Oakdale West Estate Mod 1

*State Significant
Development
Modification
Assessment
(SSD 7348 MOD 1)*

March 2020

Figure 4 | Proposed changes to Precinct 2 pad levels

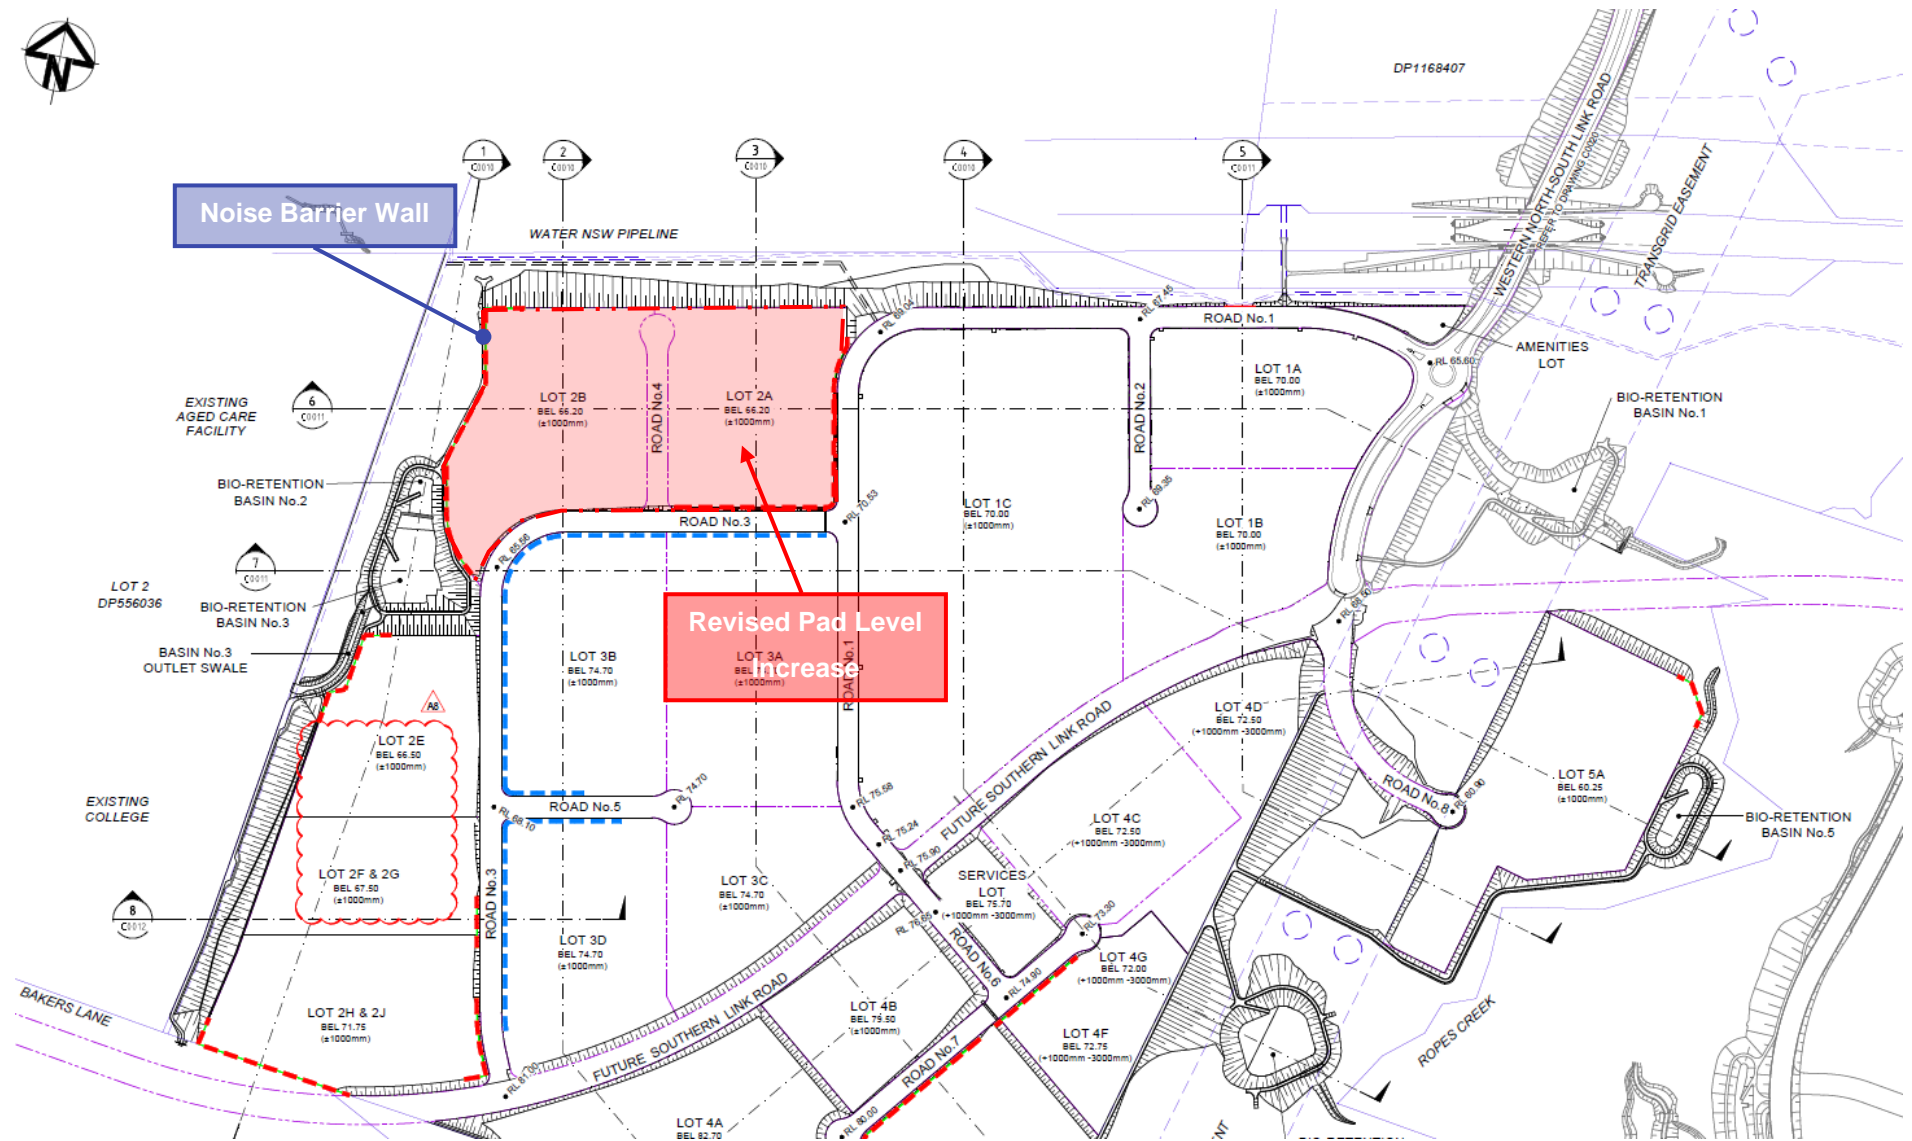
The modification includes a net 2 m increase in the building pad level heights of Lots 2A and 2B within Precinct 2, located in the north-western portion of the OWE (see **Figure 4**). These increases may present adverse visual impacts at adjoining sensitive receivers as future development on that part of the OWE would subsequently be elevated.

The Applicant proposes to raise the building pads from a relative level (RL) of 64.50 to 66.50 RL to enable internal estate roads to service future warehouse development within the estate. The increase in pad level heights would enable a reduced height transition to Estate Road 3 by 700 millimetres (mm) and subsequently result in a reduction of retaining wall interfaces for Precinct 2.

The Department has compared the modification to the original SSD approval and notes the increase of Lots 2A and 2B building pad levels would reduce the interface differentiation between the lots and Estate Road 3 to 700 mm and subsequently reduce the extent of retaining walls for Lot 2A. The Department considers the reduction in retaining walls presents an improved planning outcome in respect to the visual interface than what was originally approved.

The Department's assessment concludes the 2 m increase in the building pad levels of Lots 2A and 2B would result in negligible visual impacts on the educational and aged care facilities to the west of the estate as the approved visual vegetation buffer along the western boundary would remain sufficient to screen views of future warehouses. Furthermore, the Department considers the building pad level increase would improve the internal visual interface of the estate by reducing the extent of retaining walls.

The Department recommends Appendix 1 of the consent be modified to include plans reflecting the amended building pad level heights of Lots 2A and 2B within Precinct 2 of the OWE.

Figure 5 | Proposed changes to vegetation clearing

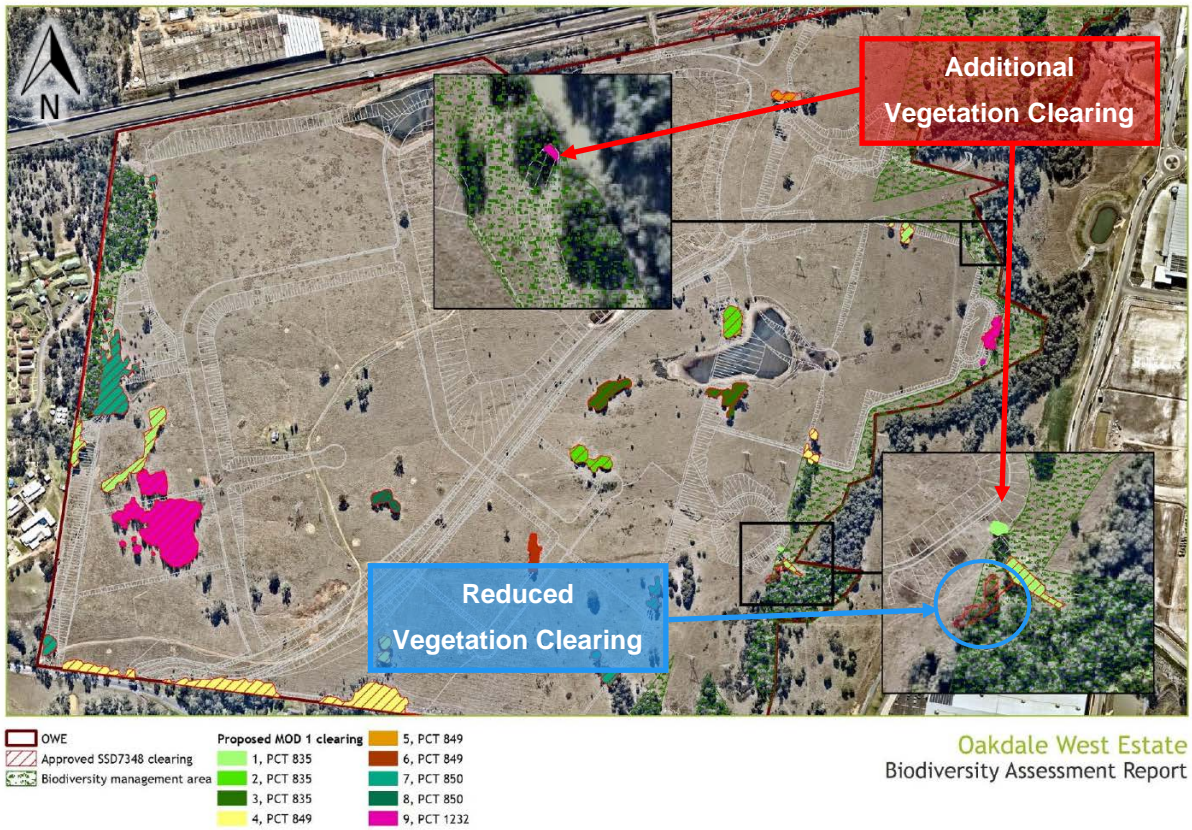
The Applicant provided a Biodiversity Assessment Report (BDAR) prepared by Ecologique to support the proposed modification. The BDAR included an updated assessment of native vegetation clearing due to proposed changes in the development footprint resulting in a reduction of native vegetation to be cleared. The BDAR identified the four Plant Community Types (PCT) approved to be cleared as follows (see **Figure 5**):

The modification proposed to incur a net change in PCT clearing of -0.03 ha from approved. Changes to PCT by coding and conditioning is outlined in **Table 2**.

The Department has reviewed the EA and amended BDAR and carefully considered the modification’s impact on biodiversity values, noting the Applicant proposes an overall reduction in native vegetation clearing and seeks to increase the number of ecosystem credits to be purchased and retired. As the BDAR concluded the modification does not result in additional impacts to biodiversity values above what was originally approved and EES has advised it concurs, the Department considers the provision of a 4.2 ha vegetation restoration zone in conjunction with the purchasing and retiring of 173 ecosystem credits to be appropriate in replacing the approved BOA and subsequently addressing the objectives of the approved BOS.

The Department recommends the conditions of consent relating to biodiversity be amended to delete reference to the BOA and reflect the changes to vegetation clearance areas and the number of ecosystem credits to be retired. In addition, a condition is recommended requiring the Applicant to restore and rehabilitate 4.2 ha of Ropes Creek riparian corridor land in accordance with the VMP.

Figure 6 | Proposed redesign of bio-retention basins No.1, 4 & 5

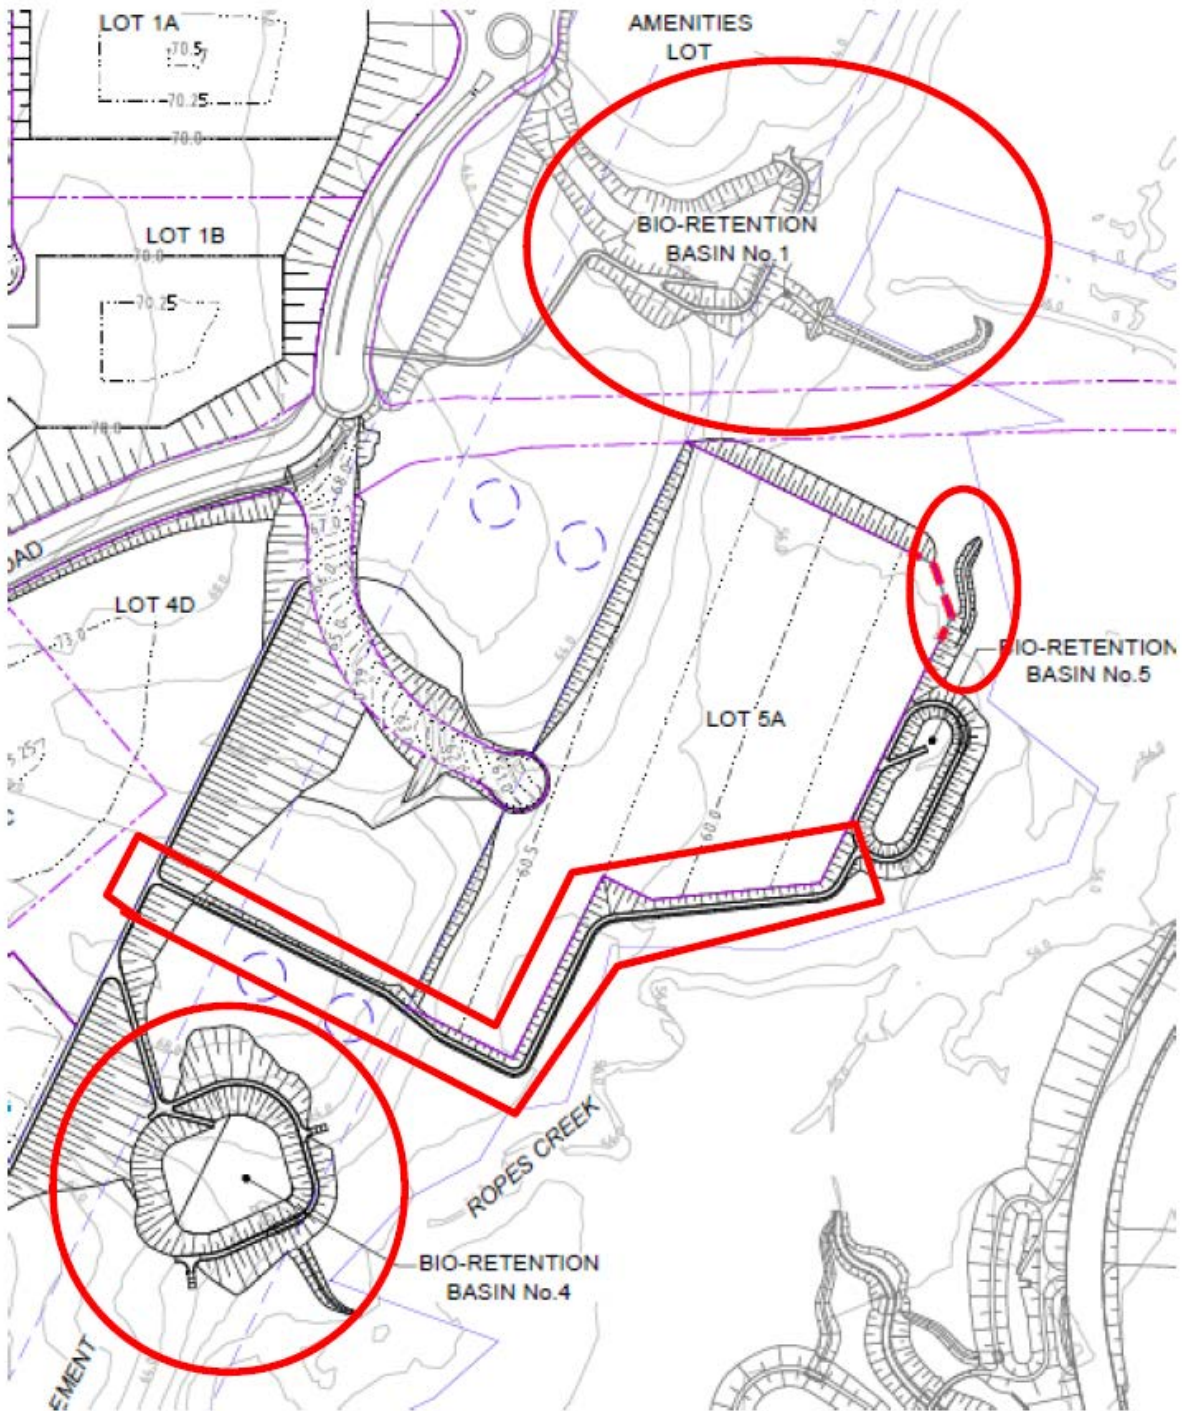
Public Utility Infrastructure	<ul style="list-style-type: none"> The modification includes the redesign of bio-retention basins 1, 4 and 5 to provide clearance from existing vegetation to reduce bio-diversity 	<ul style="list-style-type: none"> Civil works plans in Appendix 1 and 2 of the

Issue	Findings	Recommended Condition
	<p>impacts (see Figure 6). The capacities and locations of the bio-retention basins remains unchanged.</p> <ul style="list-style-type: none"> • The bio-retention basins are currently approved within an existing TransGrid transmission line easement. The re-design of the bio-retention basins may impact on the structural integrity of the transmission line tower. • The EA indicated bio-retention basin 4 provides increased battering towards existing transmission tower footings. In addition, the modification proposes a new maintenance track access to bio-retention basin 5. • The EA and submitted engineering plans identify the modified bio-retention basins will provide a 20 m clearance from the existing transmission line footings. • TransGrid reviewed the modification application and advised the proposed changes to bio-retention basins within transmission line easements are acceptable subject to works being undertaken in accordance with TransGrid's guidelines. • The Department has reviewed the re-design to the bio-retention basins and considers the modification does not interfere with the existing TransGrid transmission lines or result in additional impacts above originally approved. • The Department therefore considers the redesign of the bio-retention basins is acceptable subject to works being undertaken in accordance with TransGrid's guidelines. • The Department recommends Appendix 1 and 2 of the consent be amended to reflect the redesign of the bio-retention basins. 	<p>consent to be updated to reflect changes.</p>
